# Service Bulletin

S.B. No: **82**

**Title: INSPECTION OF WING WALKWAY AREAS**

**Applicability:** T67B, T67C Series, T67M, T67M-MkII, T67M200, T67M260 and T67M260-T3A: prior to works number 2265. Not applicable Post Mod M827C repaired aircraft.

FIGURE 1 STBD (RH) DRN - PORT (LH) SIMILAR

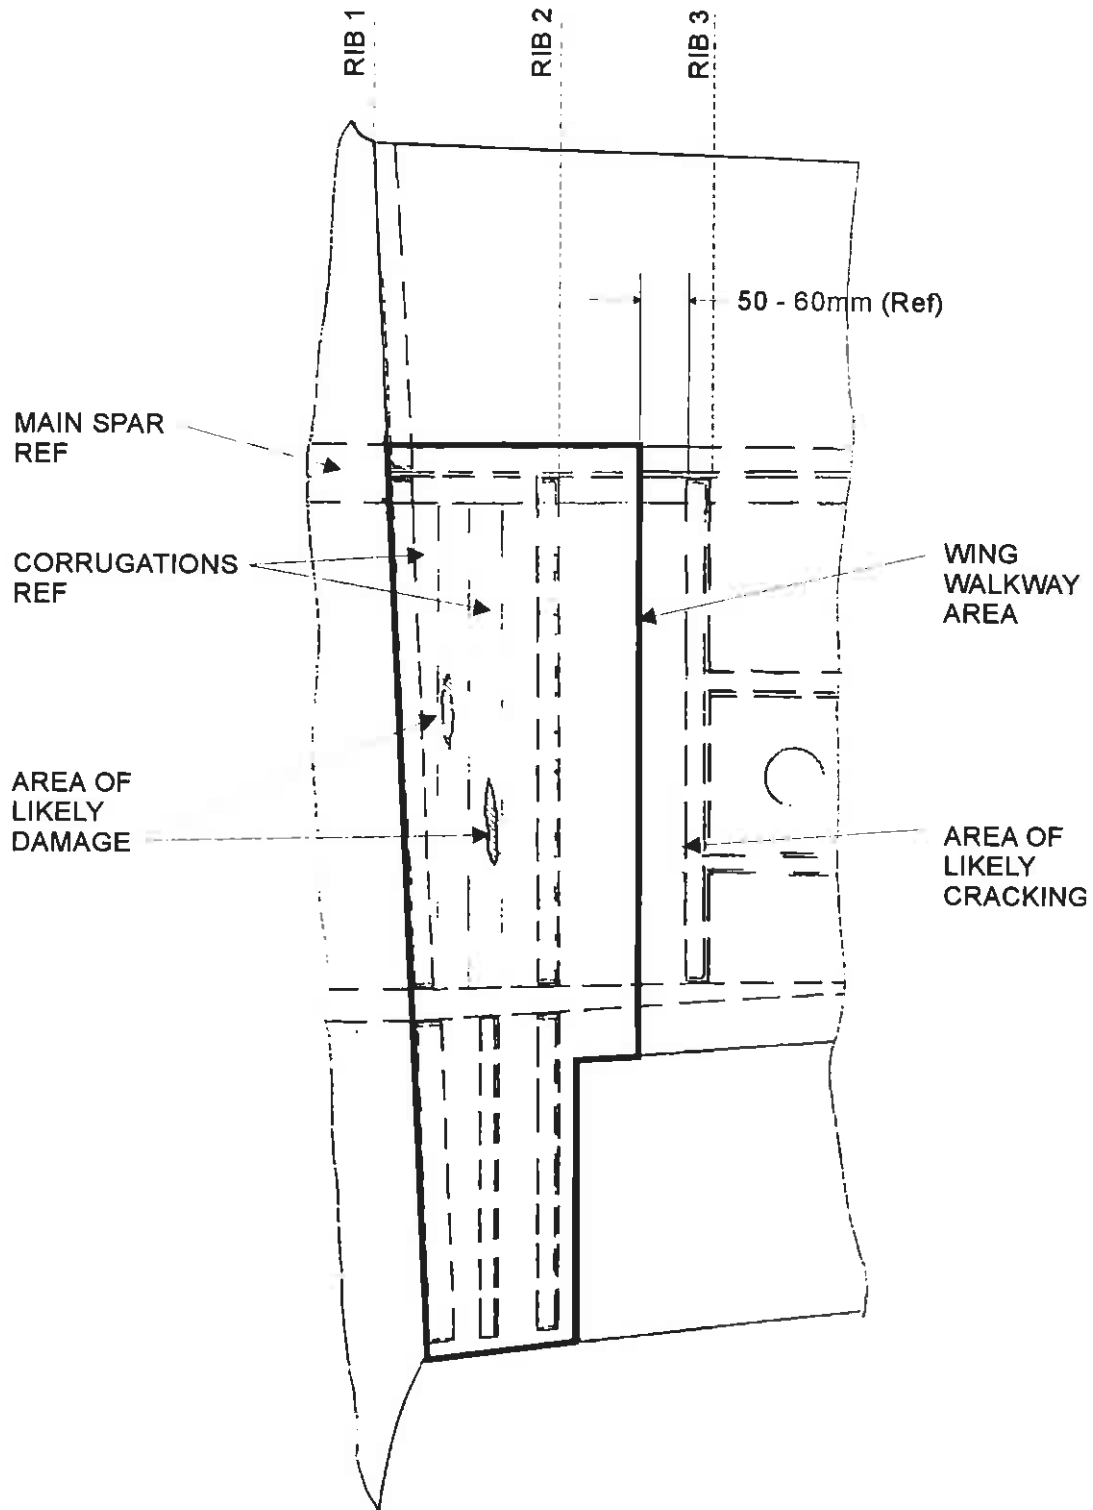
Two cases have been reported of delamination in the skin and corrugations in the area of the wing walkway. Reference Figure 1.

Subsequent to Issue 2, cracking inboard of Rib 3 flanges has been reported.

1. At next 150 (or 100 for US registered aircraft) flying hour check, reference Figure 1:
  - i. Visually inspect wing walkway area by either viewing through flap drive access hole in undersurface of wing or through Rib 1 (seats out). Also press down over wing walkway area: there should be no signs of delamination on corrugation or "spongy" feel to walkway.
  - ii. Inspect for cracking in region of Rib 3, by pressing down slightly inboard of the rib and noting any relative movement of skin.
2. If the wing is not damaged, refer to Action Matrix Reference # 1.

3. If the wing walkway area is found to be suspect or has damage, remove wing walk tape and surface finish to ascertain degree of damage. Wing walkway tape is to be carefully removed by removing wing seal, lifting corner of wing walk tape and pulling back applying gentle heat at the base of the lifted tape. Ensure the heat source is not stationary at any one point.

4. If there is damage to the wing walk way skin or corrugation refer to Action Matrix References # 2 – 5 and 8 for action to be taken.
5. If there is damage/cracks at Rib 3 then refer to Action Matrix References 6 – 8 for action to be taken.  
If in doubt, contact SACL Customer Support Department.

6. Annotate logbook SB 82 complied with and inspection added to 150, (or USA 100) hour check and appropriate Modification embodied, i.e. Mod M669 Part B or C, or Mod M827 Part B or C, as applicable.

7. Incorporation of Mod M827C terminates the repetitive inspection requirement of this Service Bulletin.
